# ROCKY FLATS SITE REGULATORY CONTACT RECORD

**Purpose:** GS10 Flume Replacement Project and Soil Disturbance Review Plan

**Purpose:** Reportable Condition at the Original Landfill (OLF)

**Purpose:** Soil Disturbance Review Plan (SDRP) for Regrading the East Perimeter Channel (EPC) and Associated Diversion Berms at the Original Landfill (OLF)

Figure 3. GS10 Flume Replacement Features

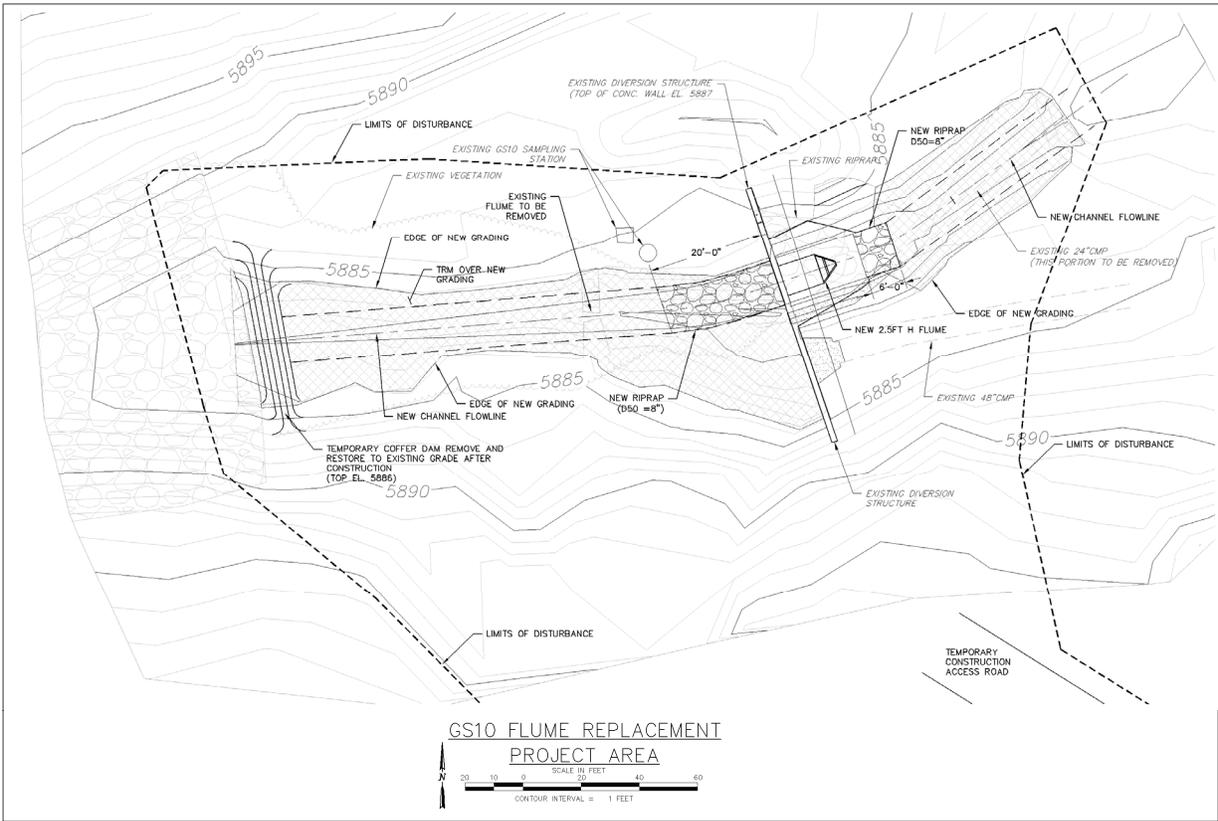
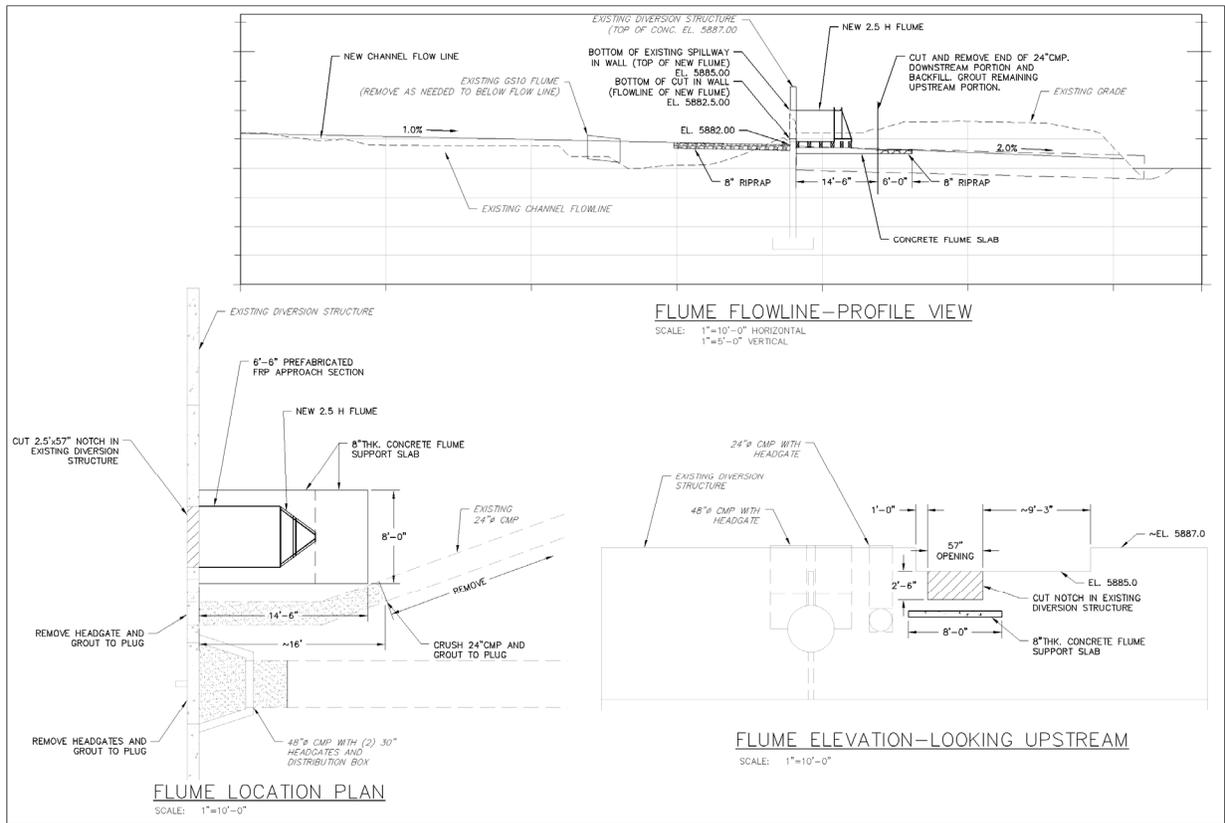
*Flume Replacement Scope and Sequence:* Figures 2 and 3 show the project area and the main features related to the work sequence.

Contact Record 2013-01 Figures 2 and 3 show the location and the lateral and vertical extent of the excavation. The material excavated from the cut areas, plus an additional approximately 11 cubic yards of clean fill will be placed in the fill areas shown in Figures 2 and 3. The source of the additional clean fill will be from onsite stockpiled soil remaining from construction and maintenance of gravel road rock crossings, from the temporary soil ramp and pad made from imported clean fill used to support the geoprobe unit in sampling of the Solar Ponds Plume Treatment System media and from the regrading of the eastern end of the Original Landfill diversion berm 7. Clean fill material may also be imported from the Bestway, Inc. commercial gravel pit located directly west of the Central Operable Unit. Depending on the availability and pricing of suitable fill material from the Bestway, Inc. pit, an alternative commercial source, such as the Pioneer, Inc. supply yard on Highway 93 just north of Golden, CO will be used. When completed, the new surface elevations will be tapered into the north and south side of the creek as shown in Figure 2, and the creek flowline will be consistent with the profile view shown in Figure 3.

**Resolution:** CDPHE has reviewed information regarding the proposed soil disturbance and excavation and, after consultation with EPA, has approved the proposed activity. CDPHE has determined that the proposed activity will not compromise or impair the function of the remedy or result in an unacceptable release or exposure to residual subsurface contamination. CDPHE has also determined that the proposed project meets the rationale and objectives of ICs 2, 3, and 7.

Figure 1. General Location of Cracking Observed on OLF Cover

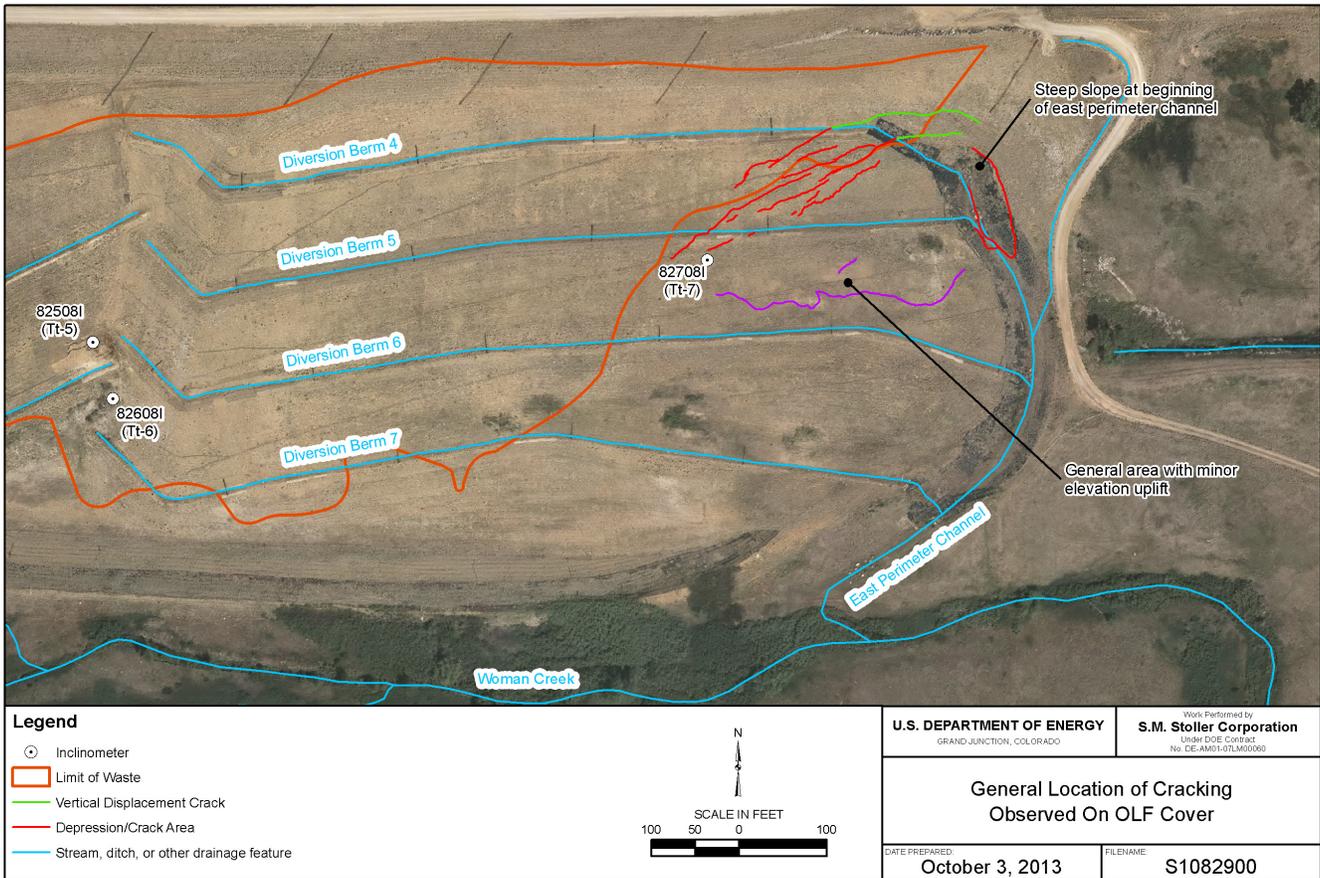
Cracks with vertical displacement of up to approximately 2 feet and cracks up to approximately 0.5 feet wide were observed during the inspection. The cracking and settling extended through portions of Diversion Berms 4 and 5, and a minor depression was formed in the Diversion Berm 4 channel between the cracks. Figure 1 shows the general location of the observed cracks based on handheld GPS measurements.

DOE informed CDPHE and EPA of the cracking on the northeast side of the OLF on September 17, 2013. DOE, CDPHE, and EPA personnel toured the area on September 18 to start the consultative process to develop a proposed course of action.

**Resolution:** CDPHE concurs with DOE’s conduct of the initial response work described above. The work meets the objective and rationale of IC 6.

CDPHE, after consultation with EPA, approves the plan and schedule for evaluation.

**Figure 1. Slope Stability Model Results**

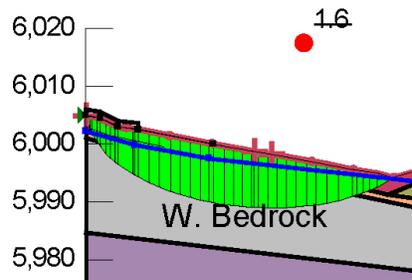
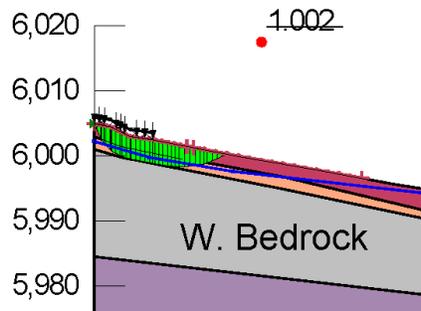
We have considered two alternative, short-term methods for reducing the occurrence of standing water in this area. Fill could be placed on the berm and in the channel invert to raise the lower portion so that positive drainage will occur across the zone. This alternative adds additional weight to the cracked area which tends to decrease the stability. Using previous slope stability models that we constructed as part of our geotechnical engineering evaluation, Tetra Tech simulated a wet condition and placement of additional fill by increasing the water level in the model and adding a surcharge to the ground surface at the failure plane. The surcharge applied approximates a two-foot layer of Rocky Flats Alluvium placed at the upper portion of the failure zone. Figure 1 (below) illustrates these conditions. Figure 1(a) shows the slope and localized failure with no surcharge, but with an elevated water level. The model calculated a minimum factor of safety (FoS) of 1.6, with failure occurring in the upper portion of the weathered claystone bedrock. Figure 1(b) shows the effect of adding a two-foot layer of fill as a surcharge. The calculated minimum FoS dropped

to 1.002 and the failure is predicted to occur in the organic layer at the surface of the weathered bedrock. These results indicate that the slope is marginally stable and on the verge of failure following the addition of two feet of fill. Because a localized, minor failure did actually occur when the water level increased, but without an additional surcharge, the model results may actually under-predict the potential risk of additional failures if surcharge is added.

Another alternative that would appear to have a lower risk for decreasing stability of the area is the construction of a temporary drain in the invert of Berm 4 to convey water from the low segment eastward to the outfall. This could be a trench and flexible drain pipe constructed such that the upper end of the drain is at the downstream end of the low segment and the drain outfall is at the eastern end of Berm 4 or in the EPC. This drain could be removed when longer term remedies have been designed and constructed (see below).

Figure 1. OLF Soil Disturbance, Filling and Grading Location

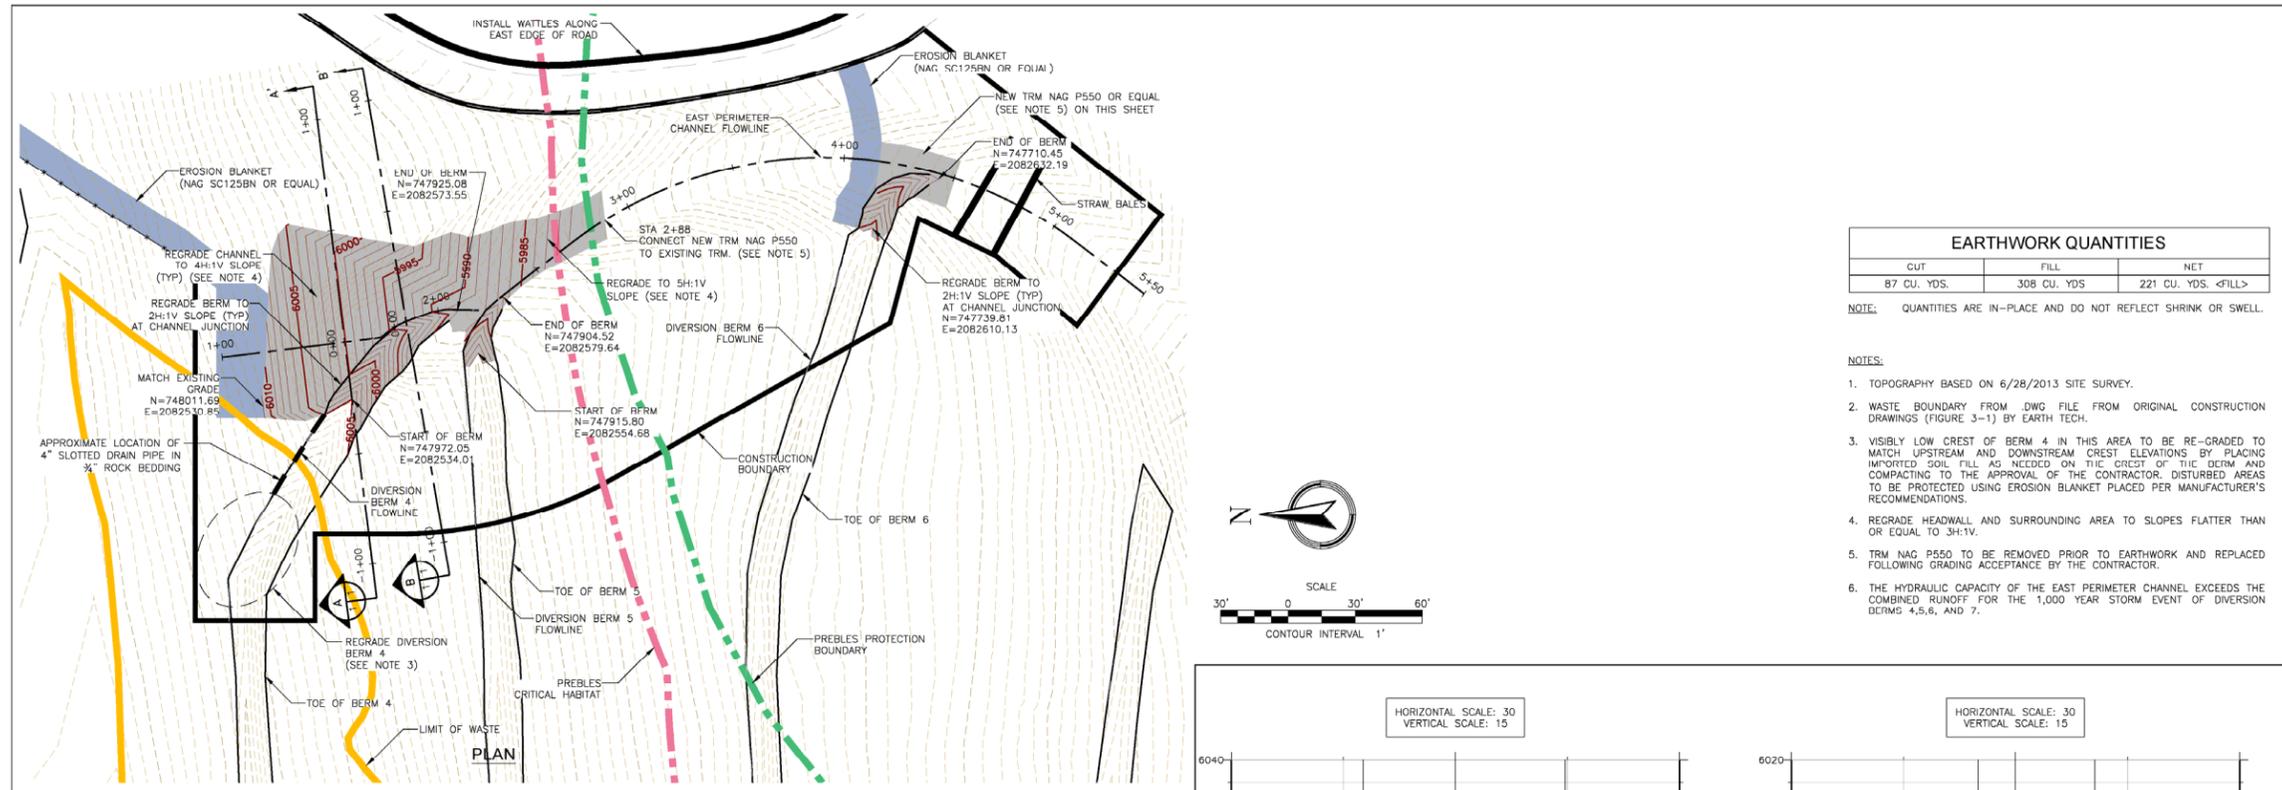
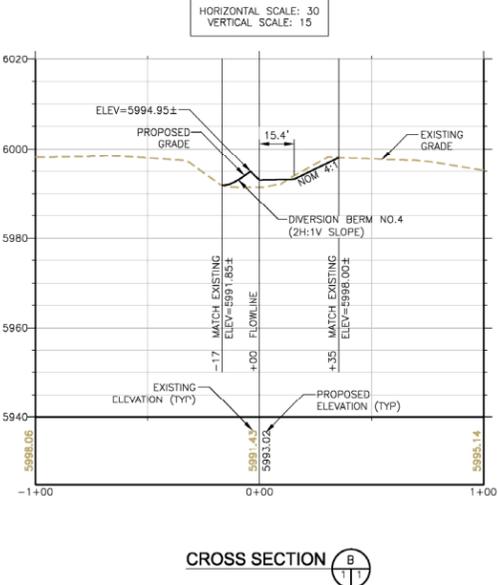
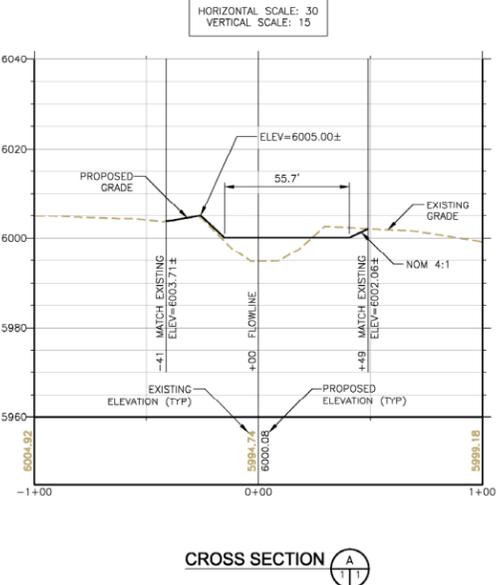
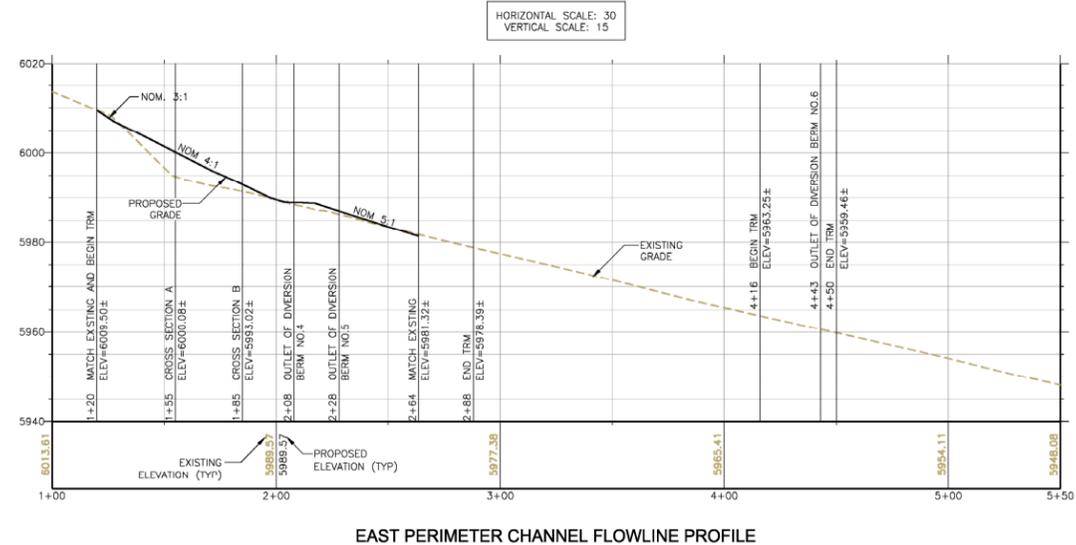
**Discussion:** DOE and CDPHE met on November 19, 2013, to review DOE's proposed grading plan which results primarily in raising the EPC elevations but some areas will have slightly lower elevations. Figure 1 shows the location and anticipated aerial extent of the soil disturbance. A slotted drain pipe bedded in crushed rock was installed in the eastern end of diversion berm 4 as part of the initial response to the localized distress (see CR 2013-02) and this will be left in place.

Contact Record 2013-03 Figure 1 shows the location and the lateral and vertical extent of the excavation and soil disturbance. The material (Rocky Flats Alluvium) (RFA) excavated from the cut areas will be used as fill in the fill areas. Additional clean RFA fill will be needed to complete the regrading. The additional clean RFA fill material will come from the Bestway, Inc. commercial gravel pit located directly west of the Central Operable Unit.

**Resolution:** CDPHE has reviewed information regarding the proposed soil disturbance and excavation and, after consultation with EPA, has approved the proposed activity and the proposed grading plan. CDPHE has determined that the proposed activity will not compromise or impair the function of the remedy or result in an unacceptable release or exposure to residual subsurface contamination. CDPHE has also determined that the proposed project meets the rationale and objectives of ICs 3 and 6.
